Our Reference: P\_21\_19\_APP\_Mamre\_WAD\_DD

**Subject: Access Logistics Park – 884-928 Mamre Road, Kemps Creek – Access Road**

In regard to the email you sent on 16 February 2023 with subject "Access Logistics Park - Meeting Minutes for the 08.02.2023", we have outlined below our responses to the actions and comments made by TfNSW.

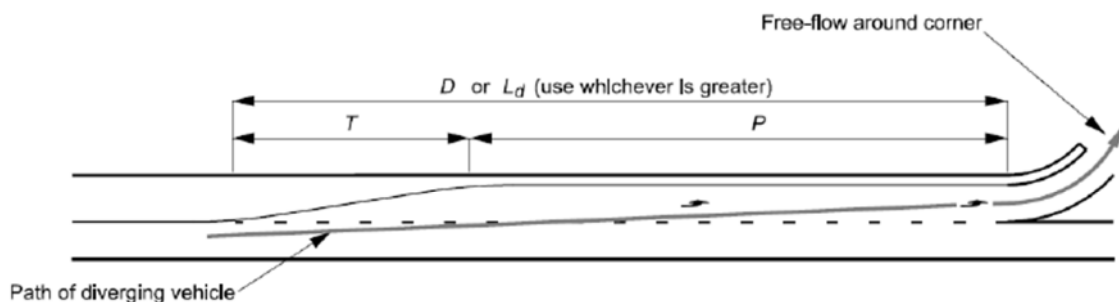
1. Permanent LILO:
  - a. TfNSW (JD and PR) requires the acceleration lane be removed and a simple left turn be installed onto Mamre Road. The redesigned LILO (as above) and deceleration lane must comply with Austroads guidelines for a 90km/h speed limit TfNSW with design details provided to demonstrate compliance.

Referring to Figure 5.1B in Austroads Guide to Road Design Part 4A (see below), the length of the deceleration lane is noted as (D)

With reference to Table 5.2 in Austroads Guide to Road Design Part 4A (see below), for a design speed of 90km/h and a design speed exit curve of 20km/h, the length of the deceleration lane (D) is required to be 120m (most conservative). **The strategic design issued to TfNSW has a deceleration lane length of 120m, which is compliant with Austroads requirements.**

**Annexure 1 – LILO Strategic Design 2021\_19\_SD\_0001\_SK00014 Issue B**

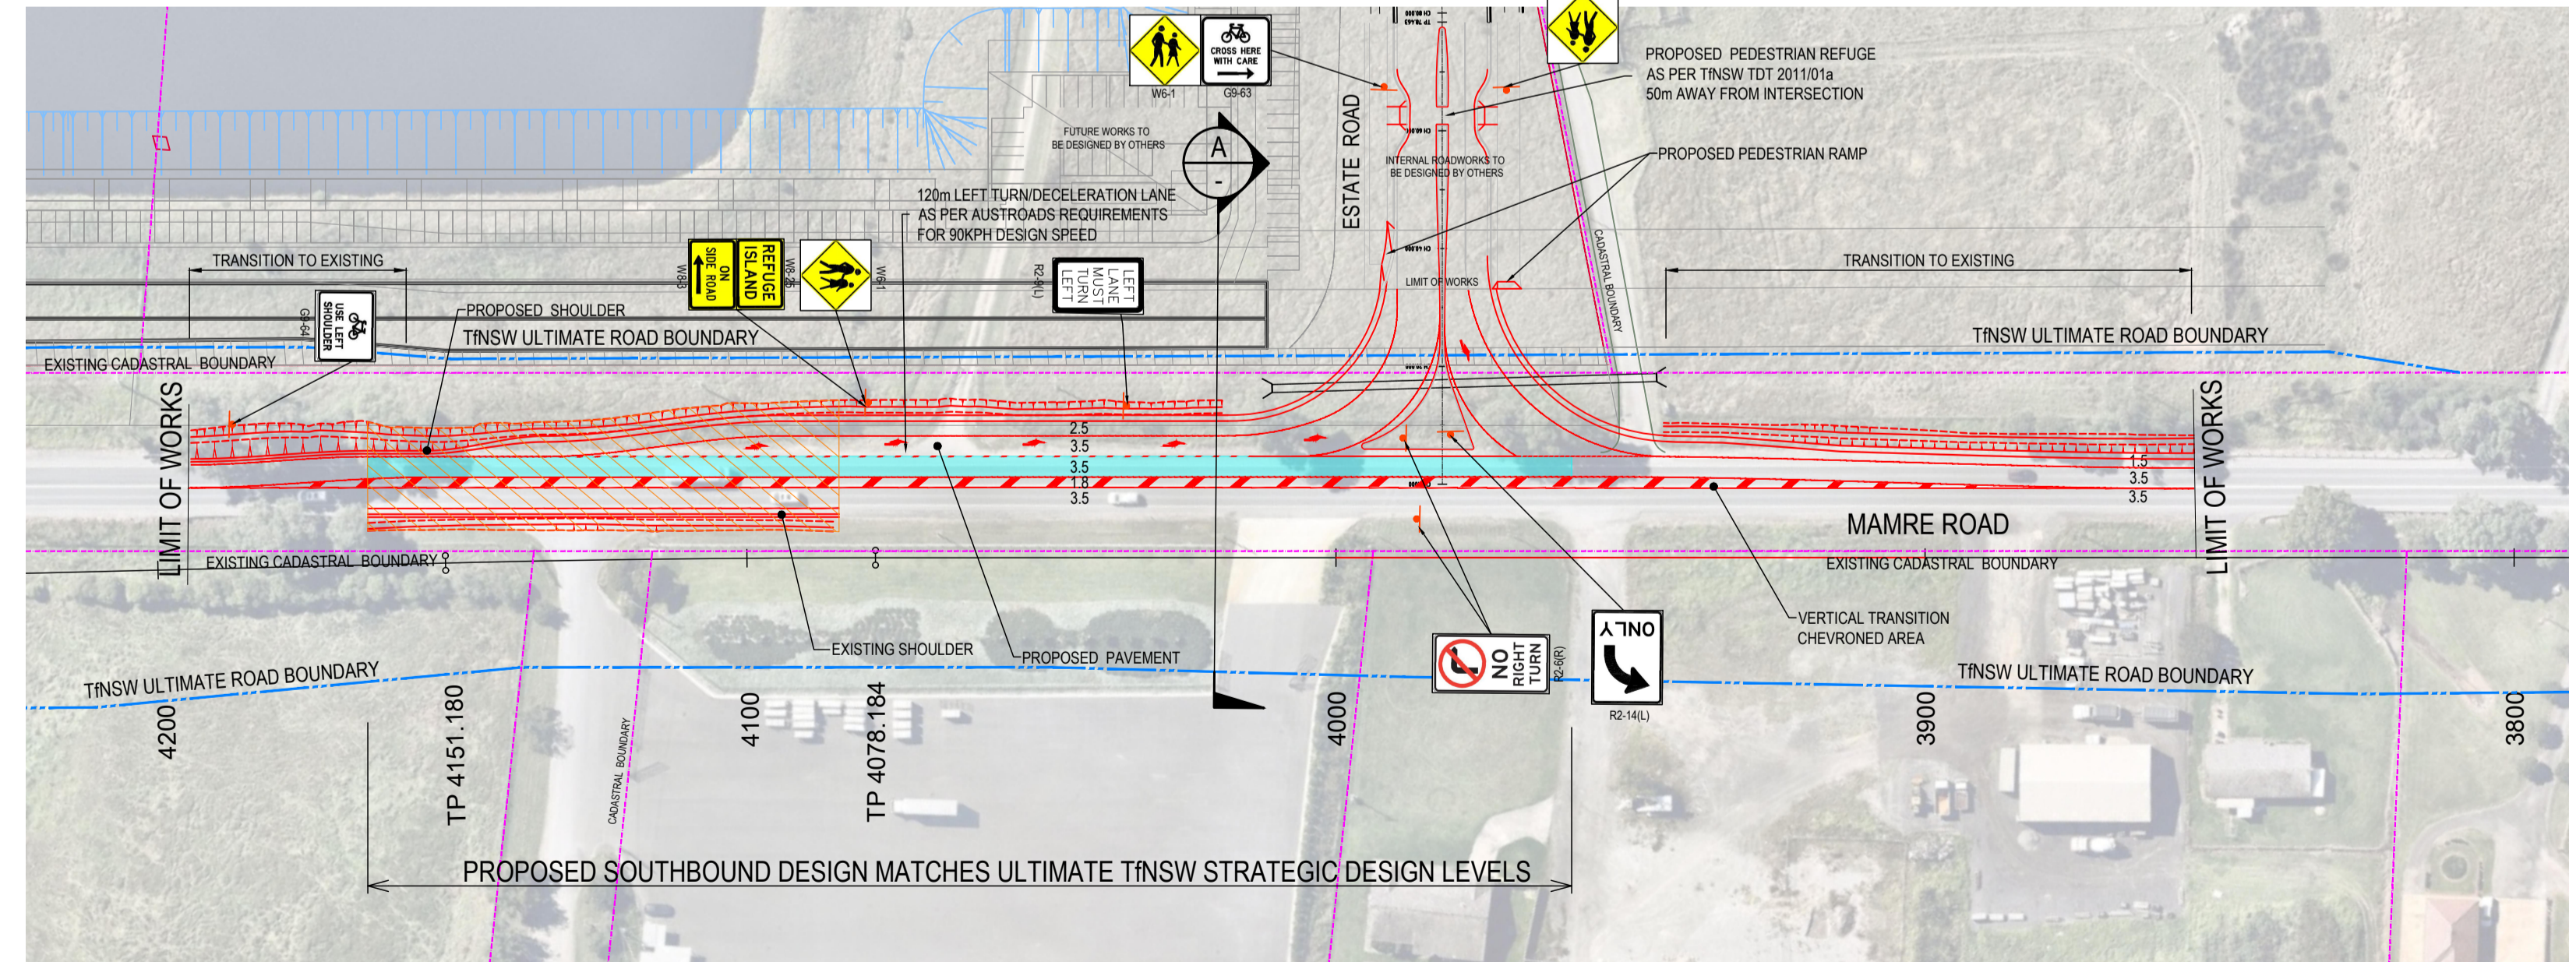
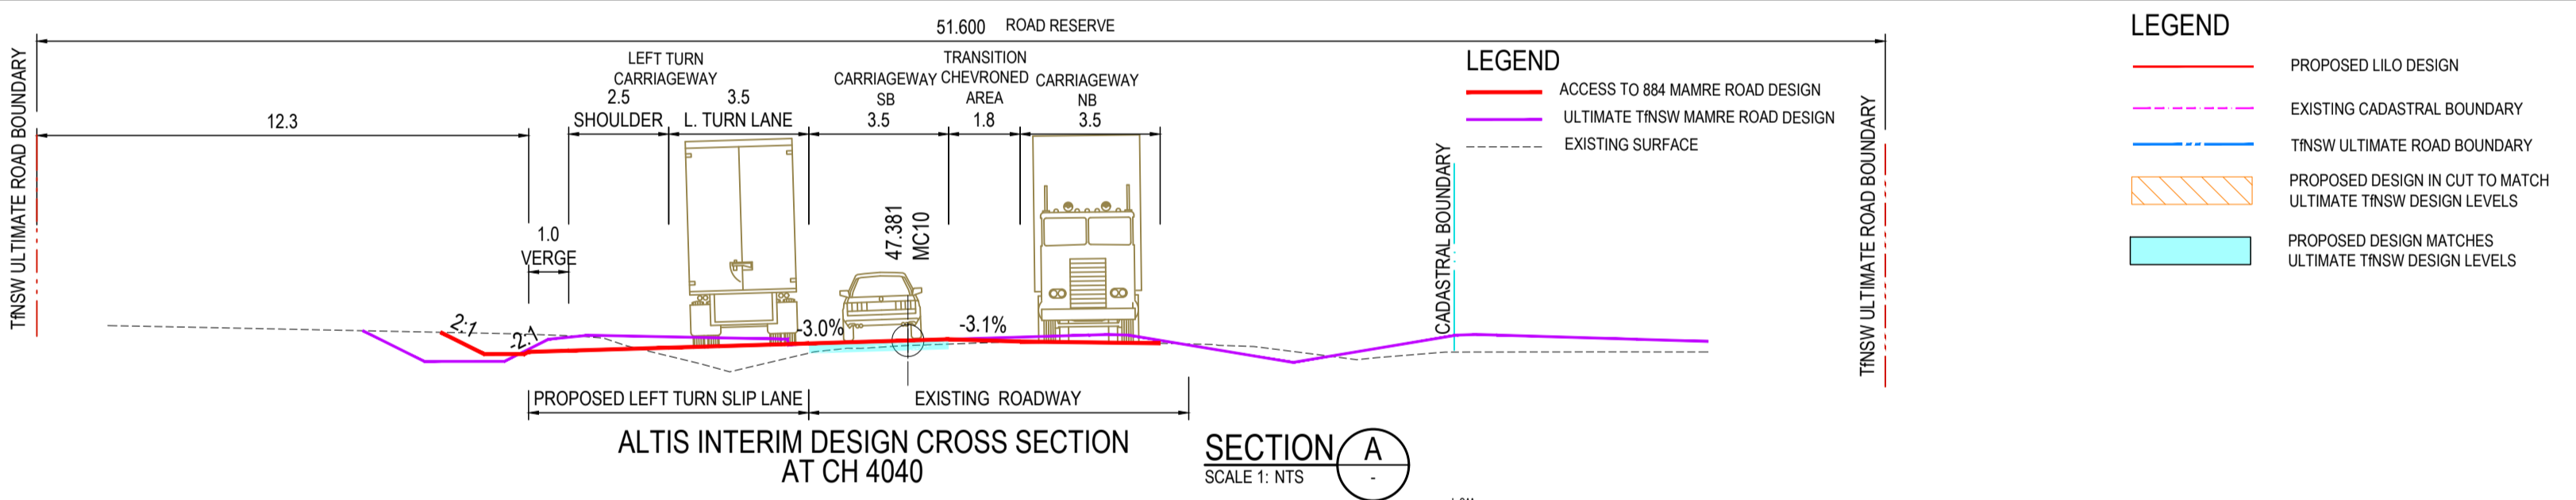
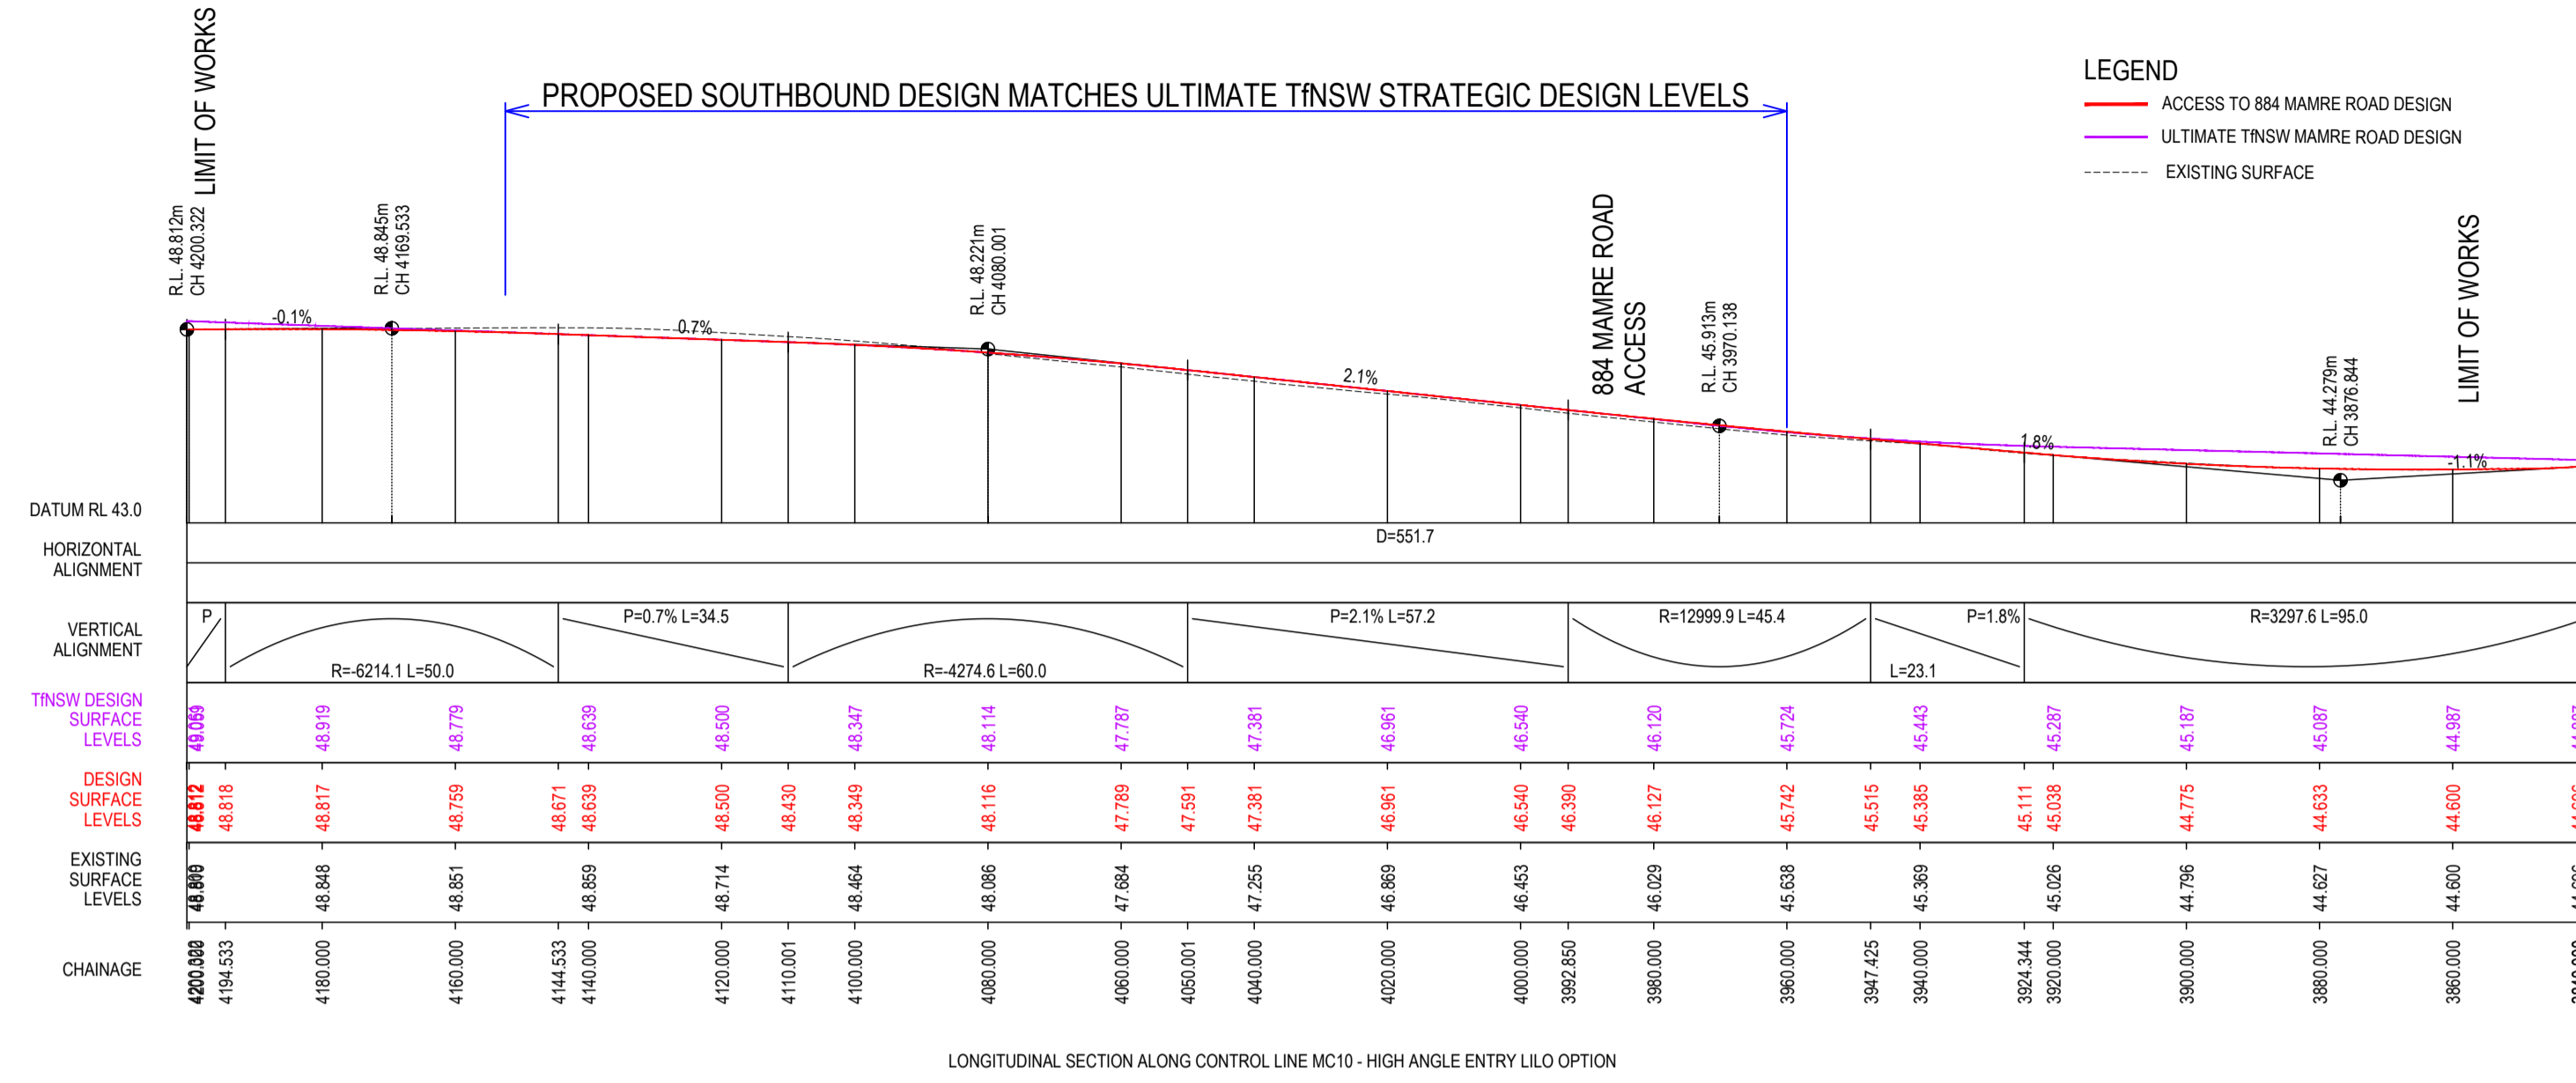
- b. TfNSW (JD) The retention of the existing driveway accesses with the 3m shoulder adjoining the deceleration lane extends across land that is not under the ownership of the Applicant or included within the current Development Application. As identified above the 3m shoulder and acceleration should be removed. Once the affected lots are developed TfNSW may consider the acceleration lane as a post development process.

2. Existing Levels and the interconnection with the Ultimate Design
  - a. TfNSW (JD) advised that the existing levels and the departure from the ultimate road arrangement must be considered given the expected vertical deviation displayed within the documentation. If the completed intersection does not match the ultimate arrangement the works would be considered sacrificial.

4. Identification of additional land adjoining the deceleration lane for future road upgrades.
- a. Action (Applicant): The Applicant is advised to identify and provide revised plans that detail the available land for future road widening (3.5m shoulder). The plan set should include a long and wide section demonstrating the potential for future land dedication.

5. The deceleration lane and subsequent land dedication for future widening in accordance with TfNSW policy please provide an amended drawing displaying that the land is available for future upgrade

The strategic design drawing (2021\_19\_SD\_0001\_SK00014 Issue B) shows a simple Left-In-Left-Out design without the acceleration lane as advised by TfNSW. This plan is provided in Annexure 1.

It should be noted that there are no existing driveways to be retained adjoining the proposed deceleration lane. The proposed design has a 2.5m shoulder adjoining the deceleration lane, which is wholly within the current road reserve (refer to drawing 2021\_19\_SD\_0001\_SK00014 Issue B) contained in Annexure 1.

We assume that this comment relates to the acceleration lane. The proposed design (2021\_19\_SD\_0001\_SK00014 Issue B) shows the acceleration lane and adjoining 3m shoulder have been removed.

Having reviewed the TfNSW Ultimate Mamre Road Strategic Design levels compared to the level of the existing Mamre Road, there will be cut and fill areas. The strategic design drawing (2021\_19\_SD\_0001\_SK00014 Issue B) shows highlighted in light blue the proposed southbound carriageway matching the Ultimate TfNSW design level including at the intersection (refer to Annexure 1). The strategic design drawing also shows via plan view and long section the cut and fill areas. It should be noted that the cut area will impact the northbound carriageway due to the level difference of approximately 250mm at the deepest level. The chevroned area at the median acts as a vertical transition for the level difference between the northbound and southbound carriageway. This vertical transition maintains an acceptable grade of approximately 3%.

The strategic design drawing (*2021\_19\_SD\_0001\_SK00014 Issue B*) shows in plan and cross section the available land for future widening. The proposed design shows a proposed 2.5m shoulder adjacent to the deceleration lane with a 1.0m verge and the remaining 12.3m available land to the ultimate road boundary.

The strategic design drawing (*2021\_19\_SD\_0001\_SK00014 Issue B*) shows in plan and cross section the available land for future widening. The proposed design shows a proposed 2.5m shoulder adjacent to the deceleration lane with a 1.0m verge and the remaining 12.3m available land to the ultimate road boundary. This plan is provided in Annexure 1
